Amendments to ECE/TRANS/WP.29/GRSP/2021/28 (UN Regulation No. 127

Submitted by the expert from OICA

I. Proposal for the 03 series of amendments to UN Regulation No. 127 (Pedestrian Safety)

"Figure 5

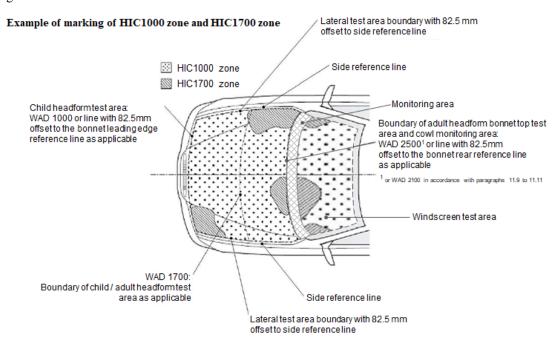
Annex 5, Figure 5., replace by:
